HISTORIC AND DESIGN REVIEW COMMISSION

HDRC CASE NO: 207-608
COMMON NAME: 421 S PRESA
LEGAL DESCRIPTION: NCB 904 LOT 41
ZONING: D, RIO-3, H
CITY COUNCIL DIST.: 1
DISTRICT: La Villita Historic District
APPLICANT: Timothy Proctor/Laney Development Group, LLC
OWNER: Fredricksburg Suites, Inc.
TYPE OF WORK: Approval of tower massing and facade materials of a thirteen story, mixed use tower
APPLICATION RECEIVED: January 5, 2018
60-DAY REVIEW: March 6, 2018
REQUEST:

The applicant is requesting conceptual approval of the massing and façade materials of a proposed thirteen story, mixed use tower. The property is bound by S Presa on the east, Cesar E Chavez on the south and S S Mary's on the west. The structure will feature structured parking as the 2nd and 3rd levels.

EXHIBIT M + Q.01
 FACADE SEPARATION AND COMPOSITION

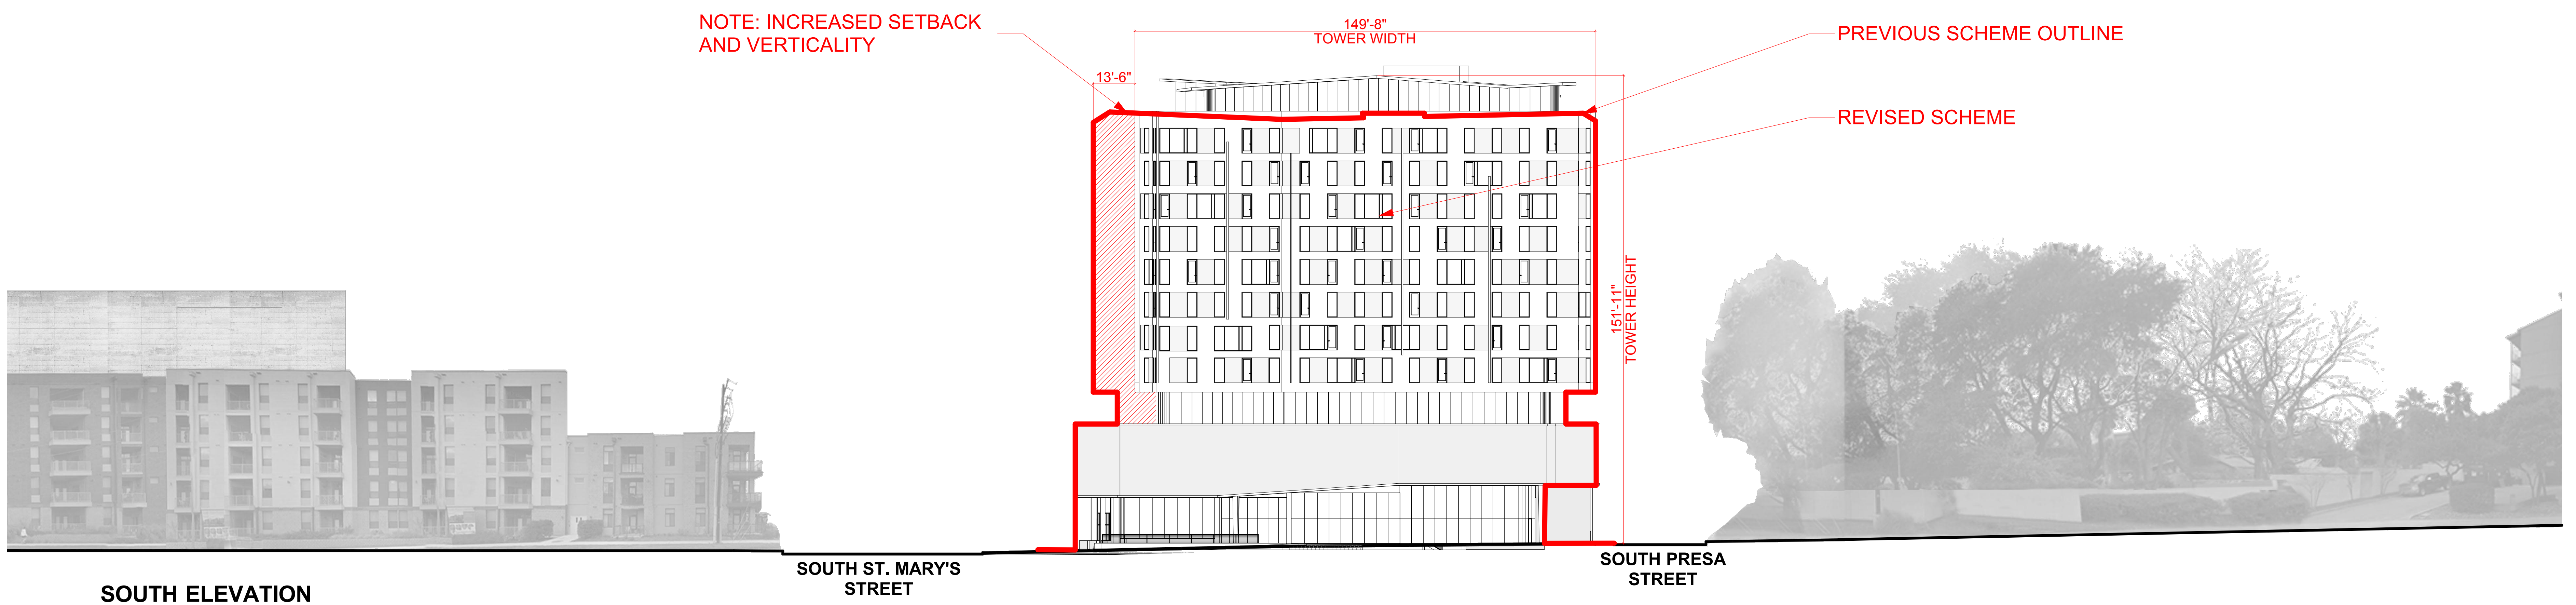
- g. **FAÇADE SEPARATION** – The UDC Section 35-674 (b)(4) notes that a façade in RIO-3 that features more than thirty (30) feet in length should be divided into modules that express traditional dimensions. The applicant has met this requirement for the tower's massing by introducing protruding balconies that span various lengths, horizontal elements that include vegetation and fenestration patterns which emphasize verticality. This is consistent with the UDC. Staff finds that the applicant should continue to develop the proposed balconies and vertical separation elements.

LE: PRIMARY CONCERN IS THE NORTH/SOUTH FACADES, ~~THE~~ DIFFERENCE

IN ELEVATION SHOULD BE INCORPORATED.

- i. That the applicant continue to develop the proposed balconies and vertical separation elements to emphasize verticality throughout each façade.
- ii. ARCHAEOLOGY- Archaeological investigations are required for all below-ground disturbing activities, including those associated with new construction. The archaeological scope of work should be submitted to the OHP archaeologists for review and approval prior to beginning the archaeological investigation. The development project shall comply with all federal, state, and local laws, rules, and regulations regarding archaeology.

PERFORATED METAL PANELS

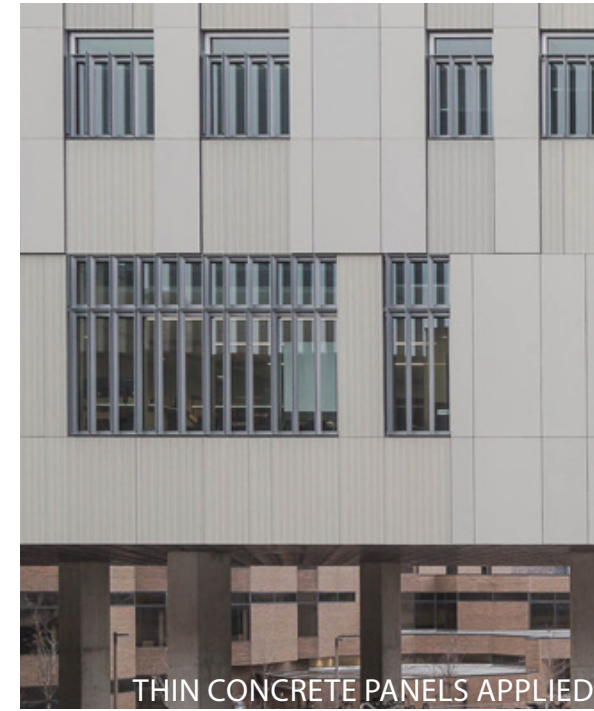
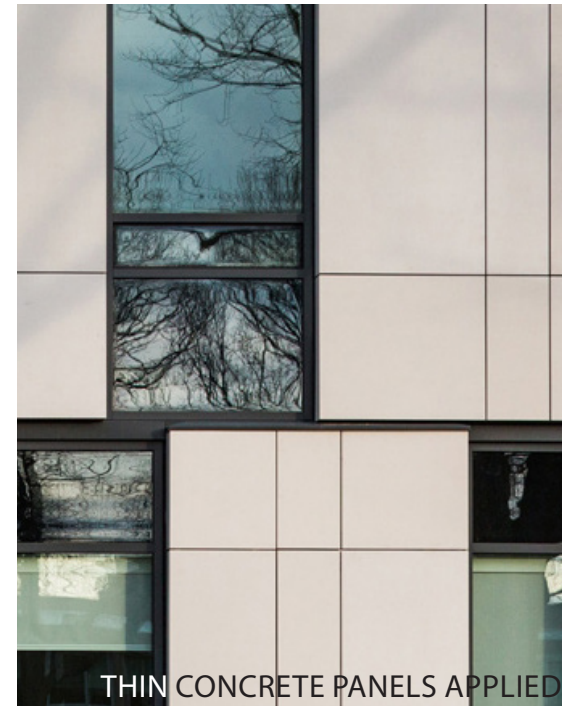
- k. **MATERIALS** – Regarding tower cladding materials, the applicant has proposed perforated metal panels and thin concrete panels. Staff finds the proposed materials to be appropriate.
